ADEQUACY OF STATION ELECTRIC DISTRIBUTION SYSTEM
VOLTAGES, OCONEE NUCLEAR STATION, UNIT NOS. 1, 2
AND 3

Idaho National Engineering Laboratory
Operated by the U.S. Department of Energy

Prepared for the
U.S. NUCLEAR REGULATORY COMMISSION
Under DOE Contract No. DE-AC07-76ID01570
FIN No. A6429

Figure 1. Oconee Electrical Single Line Diagram - Unit 1

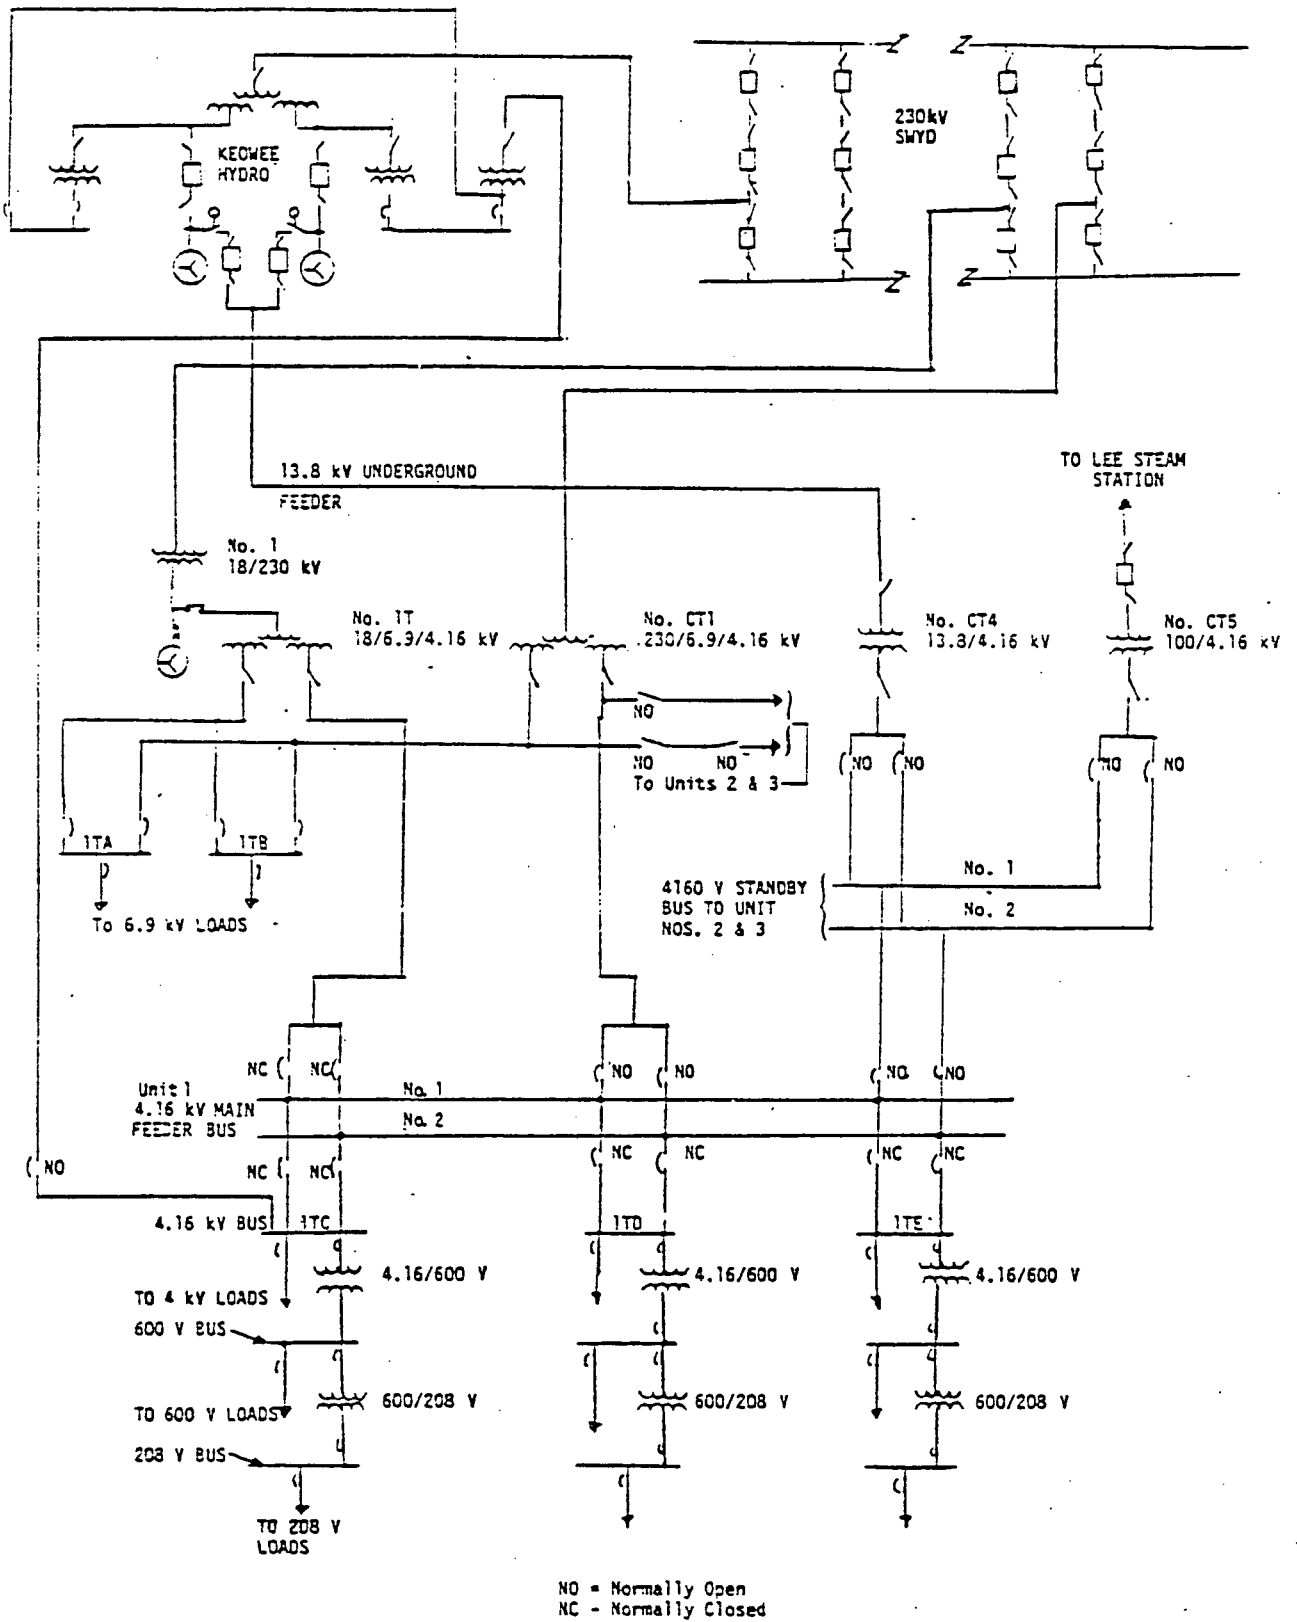
Figure 1 of this report is a simplified sketch of the Oconee electrical single-line diagram. The following description pertains to Unit 1. Unit Nos. 2 and 3 are similar.

During normal plant full-power operation, auxiliary power is supplied by the unit auxiliary transformer No. 1T and during startup and shutdown, by the startup transformer No. CT1 via the 230kV switchyard. Provisions are made for automatic fast transfer of the auxiliary loads from the unit auxiliary transformer to the startup transformer on a unit trip. A second

independent circuit is available from the 230kV switchyard (525kV switchyard for Unit No. 3) to the onsite distribution system via the main transformer and the unit auxiliary transformer for that unit when the main generator bus disconnect links have been removed. Complete loss of all offsite power will result in the automatic transfer to either of the two onsite Keowee hydroelectric generators which are capable of supplying all the emergency and shutdown loads via CT4. Emergency and shutdown loads can also be supplied from a gas turbine generator at the Lee Steam Station via CT5. This generator is isolated from the grid and is considered an onsite source.⁶

There are three essential 4.16kV buses; No. 1TC, 1TD, and 1TE. One division of safety-related equipment is powered from each of these buses. Each bus supplies 4kV loads, the 600V load centers and motor control centers (MCCs), and, in turn the 208V MCC's and the 125/250VDC systems.
